Clark & Enersen Project No.: 097-045-19
LPS Bid #: 11090

ADDENDUM NO. 1

LPS Southeast Activities Complex

First Floor Lighting Plan (Phase 1)

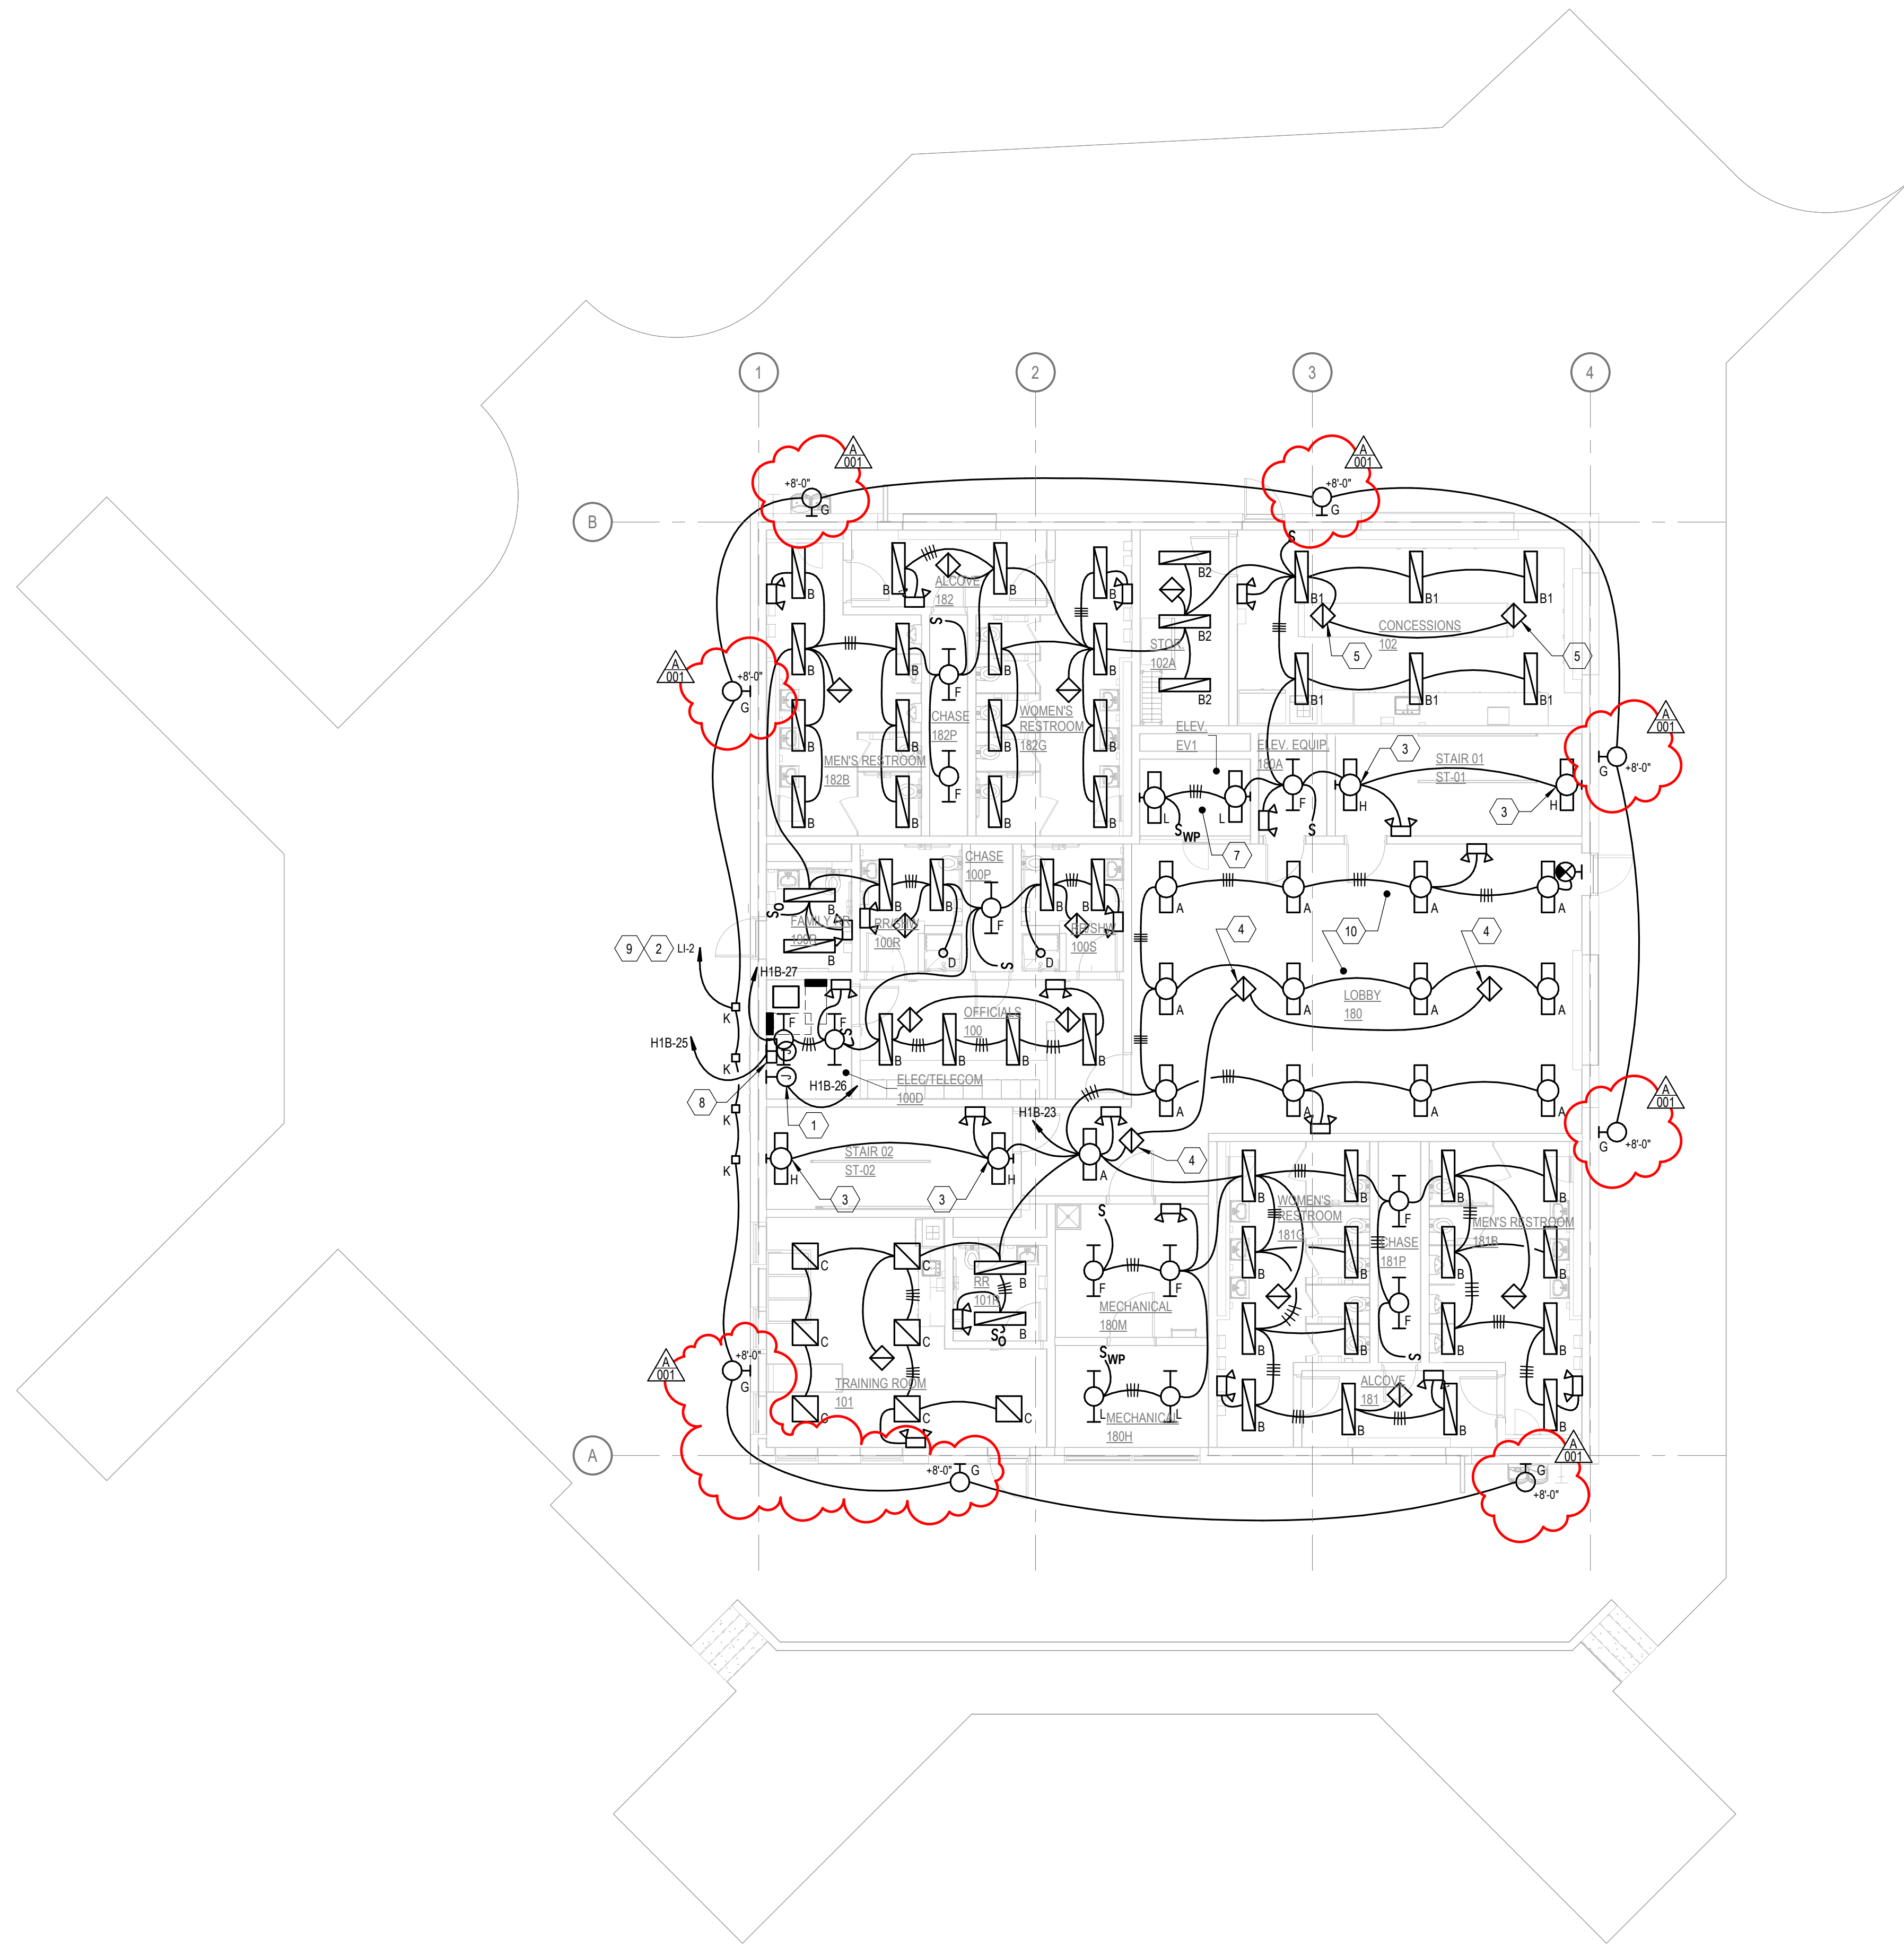
This sheet has been revised and reissued in its entirety as part of this addendum to clarify exterior light fixture mounting heights, and show the addition of one exterior light fixture.

Telecommunications
 Risers & Details Plan

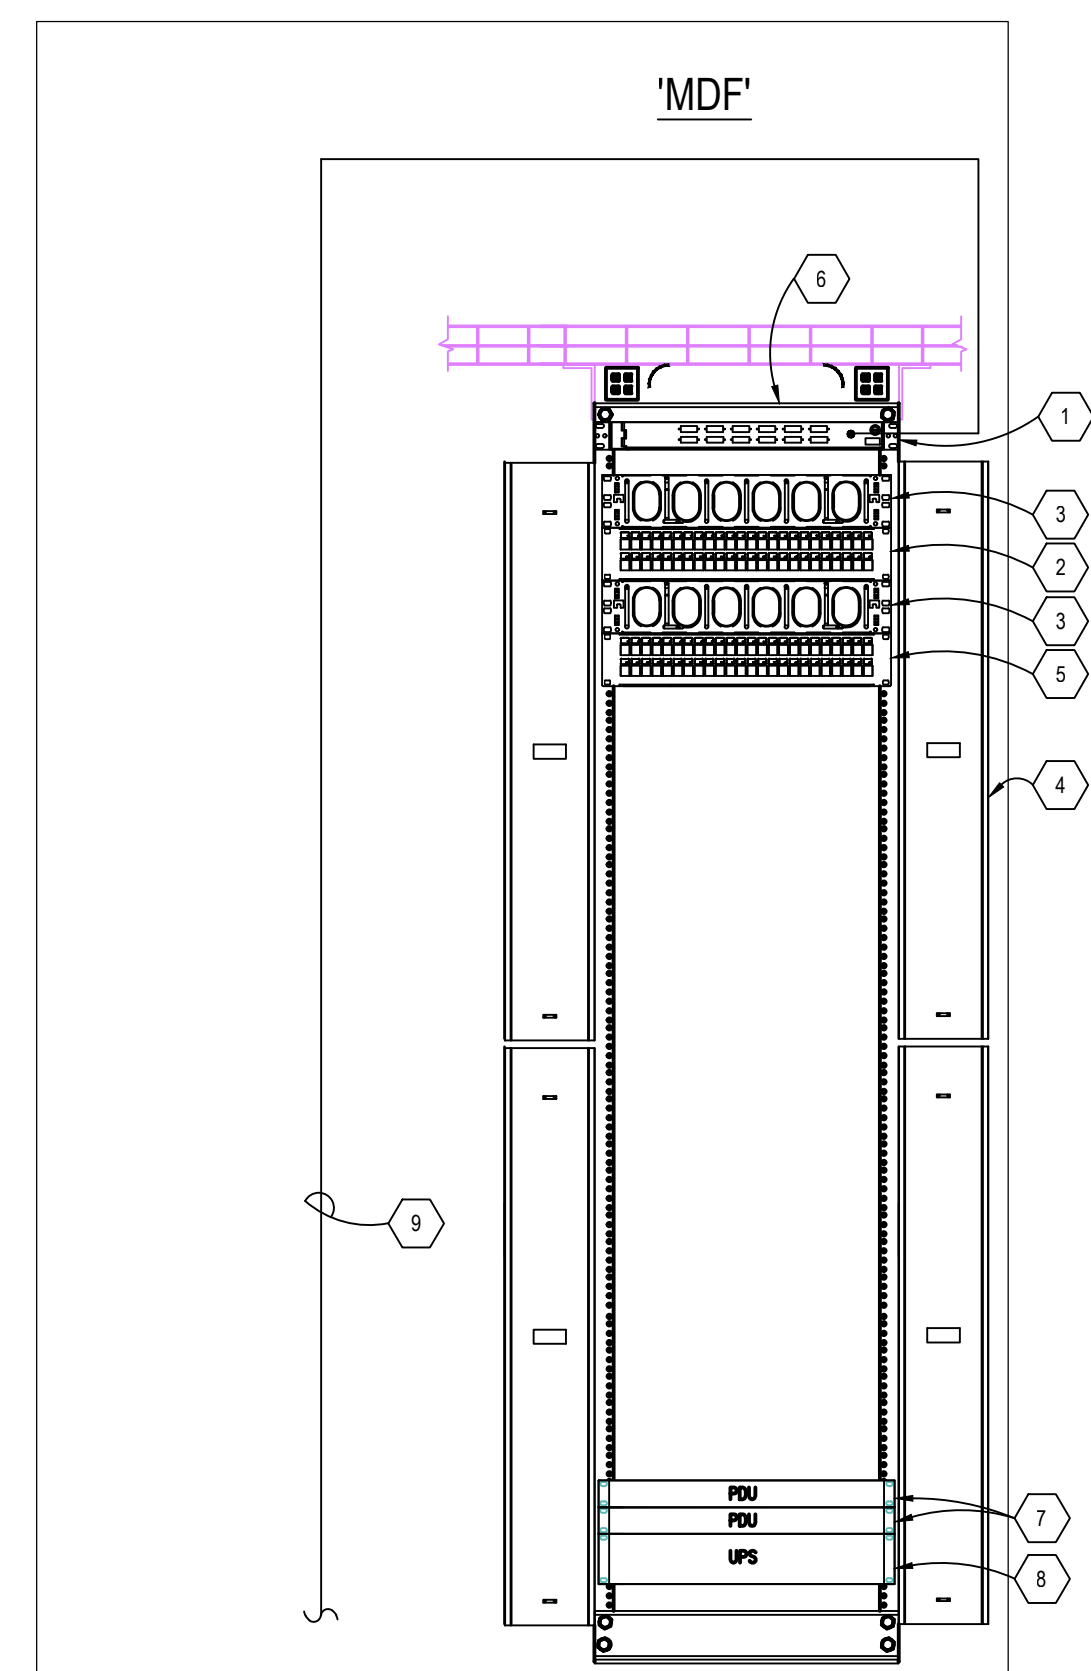
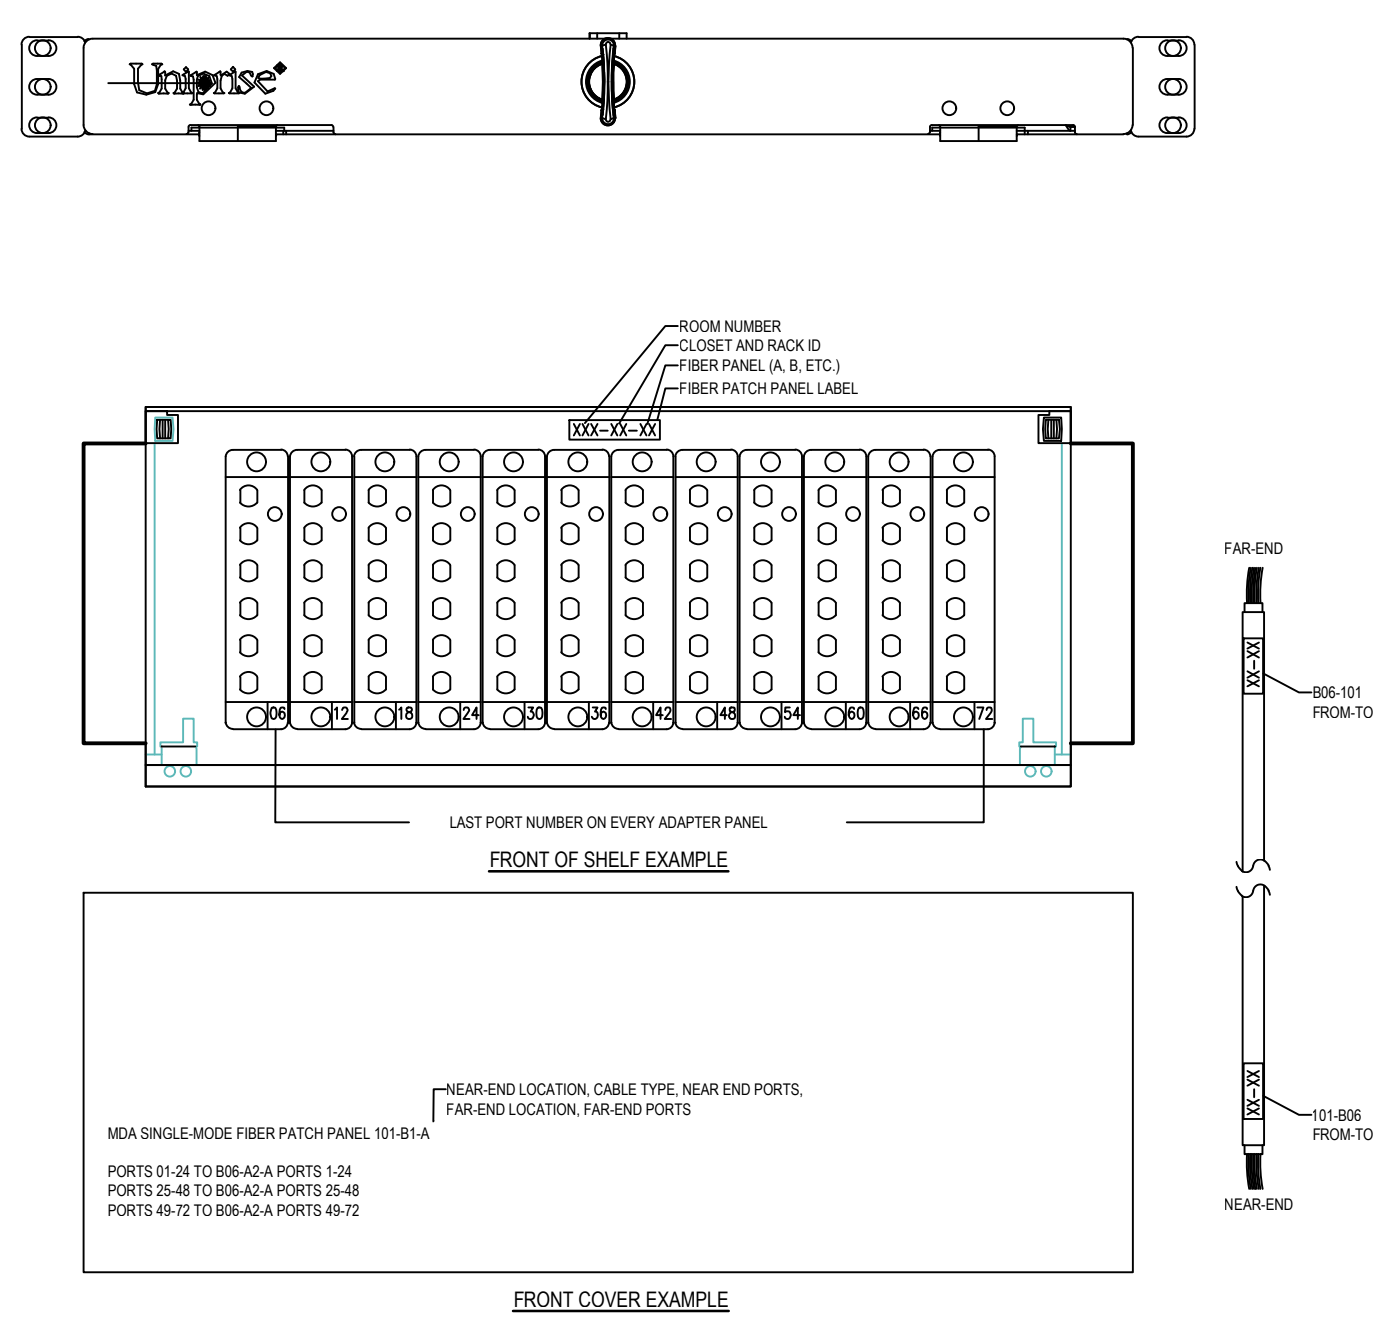
This sheet has been revised and reissued in its entirety as part of this Addendum to show new fiber back to the school, in lieu of splicing.
